STAFF REPORT 9-8-2021 REGULAR MEETING

APPLICATION NUMBER: 21-7395

ADDRESS: 4784 STURTEVANT STREET

SCOPE: DEMOLISH EXISTING GARAGE, REPLACE COLUMNS AND RAILING AT FRONT PORCH

Existing conditions at west (left side) porch column. Applicant photo.

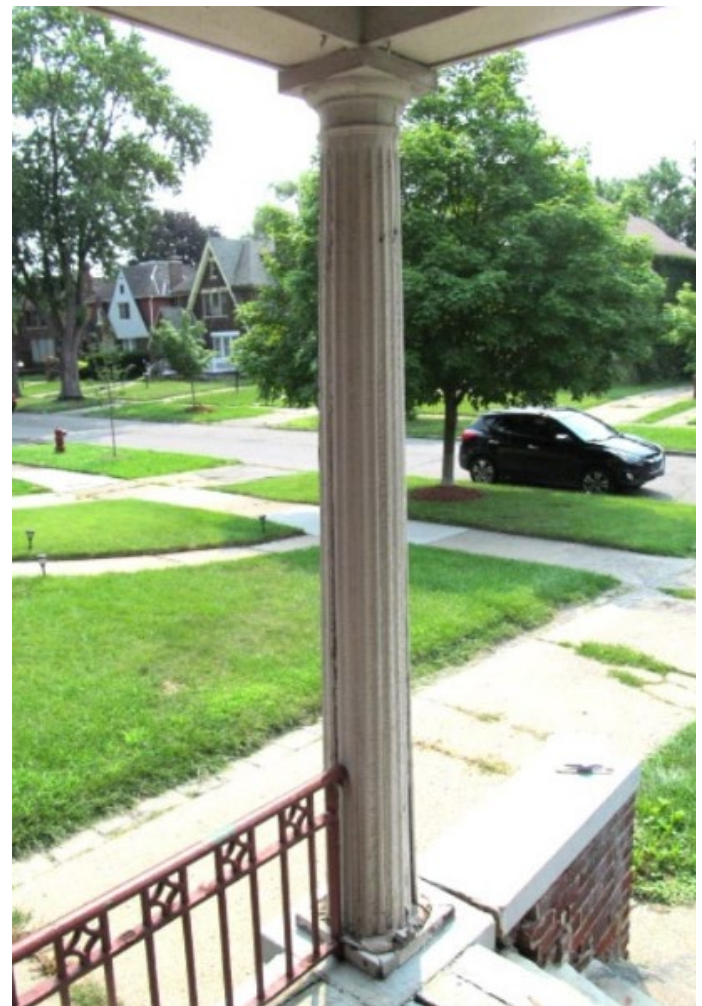
- The tapered, fluted wood columns are distinctive and important character-defining features of the property. It is staff’s opinion that the east column (right side) appears to be beyond repair and may require replacement. It is staff’s opinion that although the west column (left side) demonstrates the need for repair at the base, does not appear to be beyond repair.

- The proposal to replace the west column (left side) does not meet Standard 6 as it does not appear beyond repair. It is staff’s opinion that the west column (left side) should be repaired rather than replaced. While the east column (right side) may require replacement, the material and size (16” diameter) of the proposed replacement columns (fiberglass reinforced polymer) is an inappropriate material as it does not match the existing material or diameter of the distinctive feature.
- The proposed removal and replacement of the existing 24” high decorative wrought iron railing removes historic materials that characterize the property.

It is staff’s opinion that the proposal to replace both existing fluted, tapered wood columns with new fiberglass reinforced polymer (FRP) columns and the proposal to remove and replace the existing 24” high decorative wrought iron porch railing removes historic materials and is inappropriate with respect to the character of this property and its environment. Staff therefore recommends that the Commission issue a Denial for the proposed work because it does not meet the Secretary of the Interior’s Standards for Rehabilitation and the Russell Woods – Sullivan Elements of Design, especially Standards:

(6) Deteriorated historic features shall be repaired rather than replaced. Where the severity of deterioration requires replacement of a distinctive feature, the new feature shall match the old in design, color, texture, and other visual qualities and, where possible, materials. Replacement of missing features shall be substantiated by documentary, physical, or pictorial evidence.

Section 21-2-78, Determinations of Historic District Commission (Demolition/dismantling of existing garage)

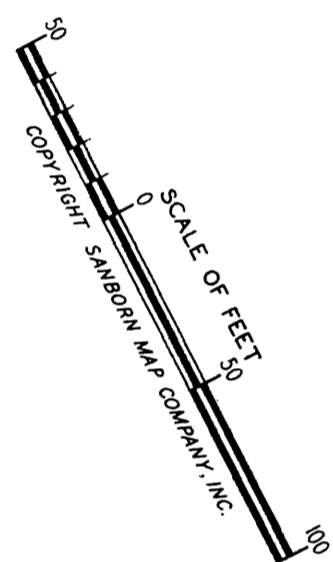
- Russell Woods – Sullivan Historic District was designated in 1999.
- It is staff’s opinion that the existing garage has lost historic integrity and no longer contributes to the overall historic character of the property.

It is staff's opinion that the proposal to demolish the existing garage by dismantling and removing all construction debris and the proposal to retain the existing concrete slab and surrounding trees should qualify for a Certificate of Appropriateness. Staff recommends that the Commission approve a COA for the proposed application, as it meets the Secretary of the Interior's Standards and the Russel Woods – Sullivan Elements of Design.
